MultiCare Good Samaritan Hospital Kitchen

07.25.2025
PW PROJECT #162433.000

PHASE 2 CONSTRUCTION DOCUMENTS

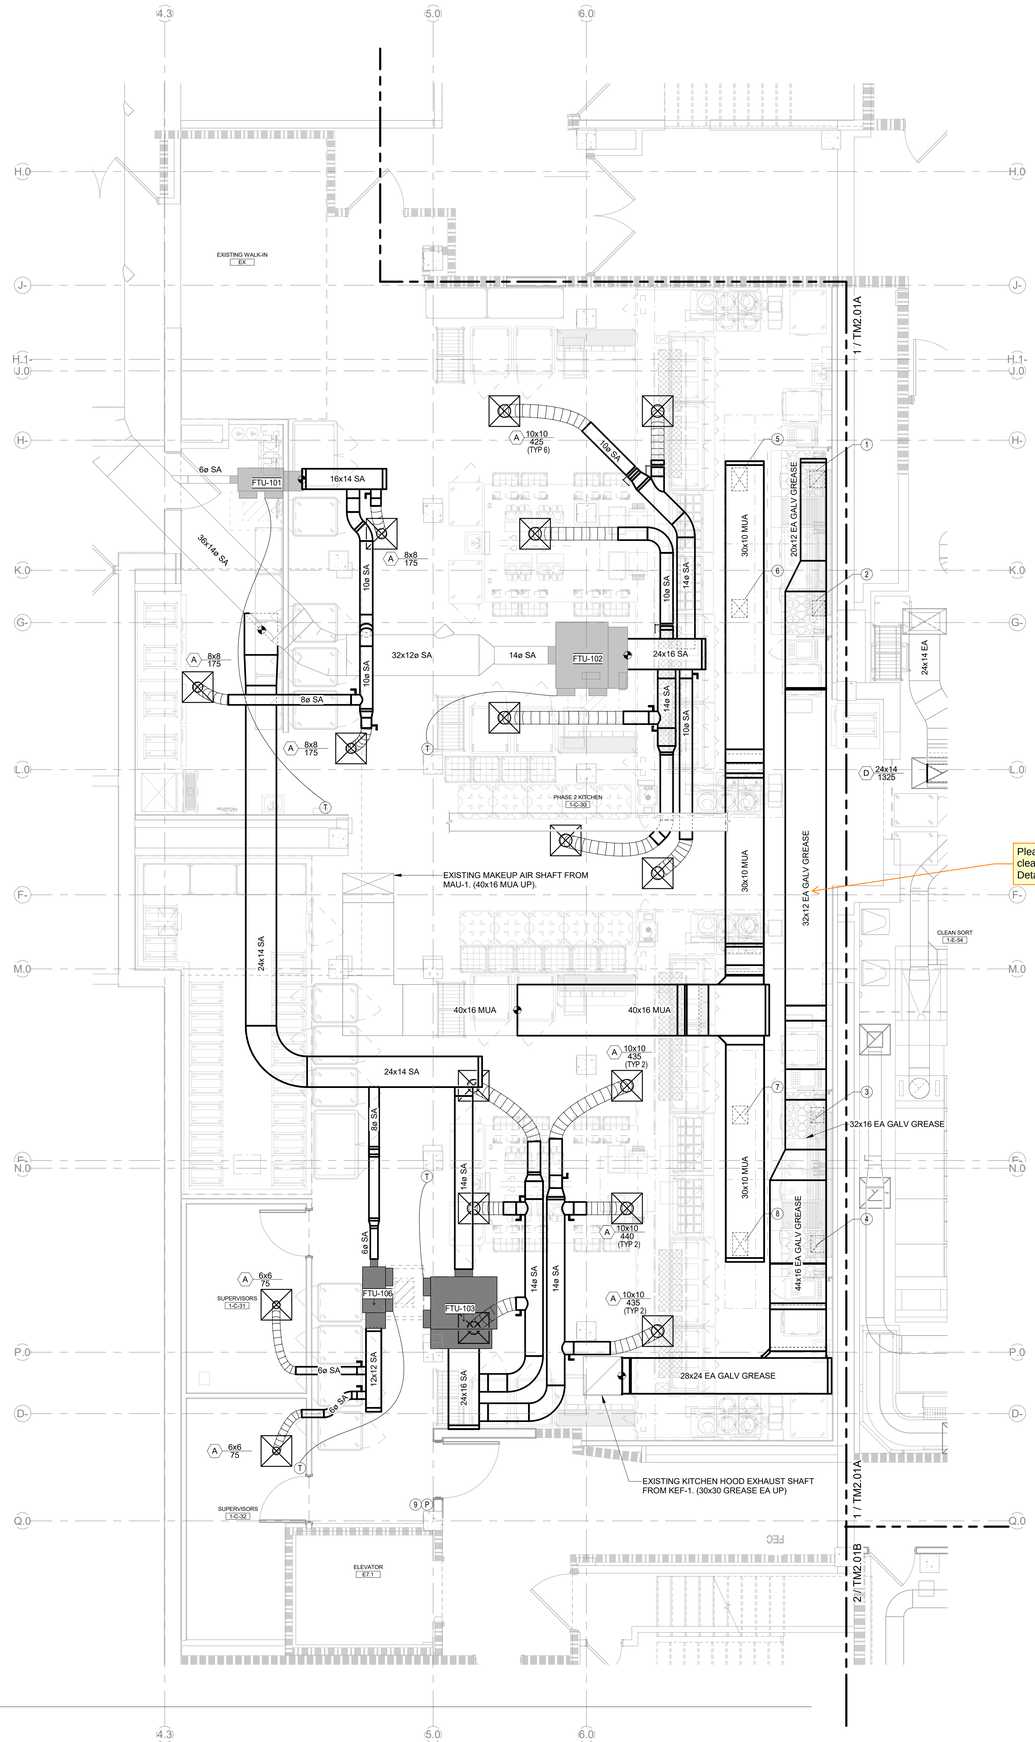
Please provide 506.3.8 Grease duct cleanouts and openings. Details and locations.
